Subject Service Campaign - New layout for ground wiring

New layout for ground wiring

All Gallardo models until VIN 2624

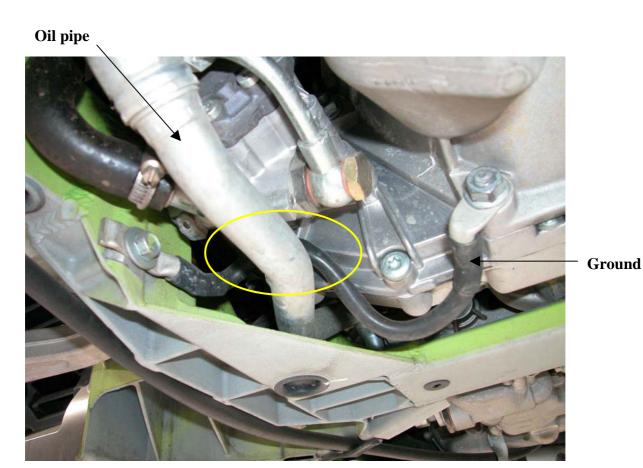
- **1.1** Adopt all precautions to prevent car damages and to work safe.
- **1.2** Raise the car on the lift.
- **1.3** Disconnect the wiring on both sides sides and reconnect it positioned over the engine oil pipe as shown in the picture below.
